# UNITED STATES PATENT AND TRADEMARK OFFICE

APPLICATION NO.	FILING DATE	FIRST NAMED INVENTOR	ATTORNEY DOCKET NO.	CONFIRMATION NO.
10/761,856	01/20/2004	Olaf Kruse	RICHT-45041	3074
26252 7:	590 11/21/2005		EXAM	INER
KELLY LOWRY & KELLEY, LLP 6320 CANOGA AVENUE			DOLINAR, ANDREW M	
SUITE 1650			ART UNIT	PAPER NUMBER
WOODLAND HILLS, CA 91367		•	3747	•

#### **DETAILED ACTION**

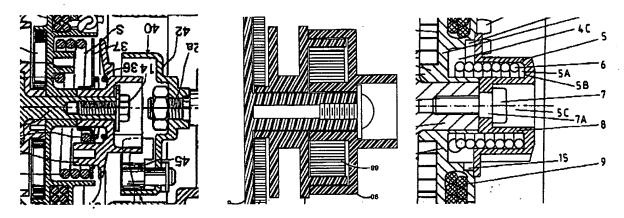
Applicant's arguments have been fully considered but they are not persuasive. The similarity of the element 8 identified as the "bushing or sleeve" and corresponding elements of the prior art is evident from the below side by side comparison applicant's starter (right) with those of Kawasaki et al (left) and Liesure et al (center).

The claims set forth no detail of structure that would serve to distinguish over the references as applied. One must bear in mind that, especially in nonchemical cases, the words in a claim are generally not limited in their meaning by what is shown or disclosed in the specification. See, e.g., *Liebel-Flarsheim Co. v. Medrad Inc.*, 358 F.3d 898, 906, 69 USPQ2d 1801, 1807 (Fed. Cir. 2004).
